# METROPOLITAN GOVERNMENT OF NASHVILLE AND DAVIDSON COUNTY

## STAFF RECOMMENDATION 1512 Paris Avenue November 20, 2013

**Application:** New construction- infill and outbuilding  
**District:** Belmont-Hillsboro Neighborhood Conservation Zoning Overlay  
**Council District:** 18  
**Map and Parcel Number:** 11704040900  
**Applicant:** William Smallman, Owner  
**Project Lead:** Sean Alexander, sean.alexander@nashville.gov

**FRONT (STREET) ELEVATION**  
SCALE: 1/4" = 1'

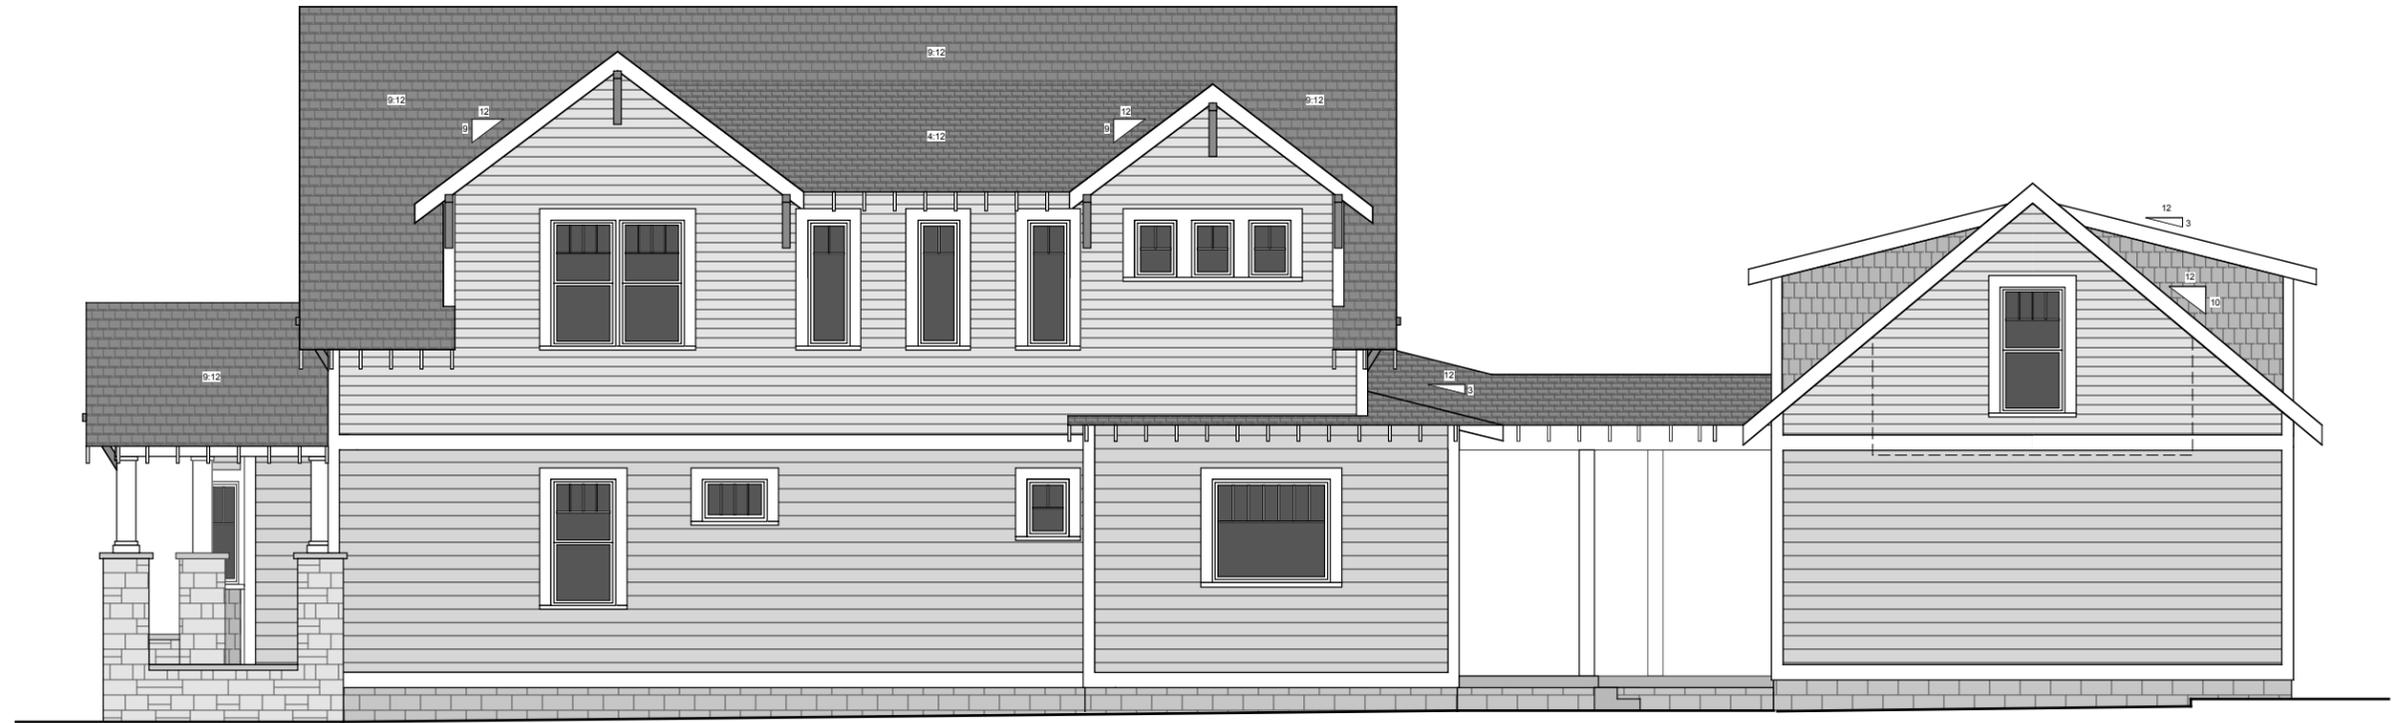
- Staff approve the color of the roof and the materials of the windows and doors;
- The upperstory windows are generally not taller than those on the first story on the front elevation;
- A walkway be added from the front porch to the street, and that the location of HVAC units and utilities be approved by Staff; and,
- The cover over the walkway from the garage be reduced.

- Staff approve the color of the roof and the materials of the windows and doors;
- The upperstory windows are no taller than those on the first story on the front elevation;
- A walkway be added from the front porch to the street, and that the location of HVAC units and utilities be approved by Staff; and,
- The cover over the walkway from the garage be reduced.
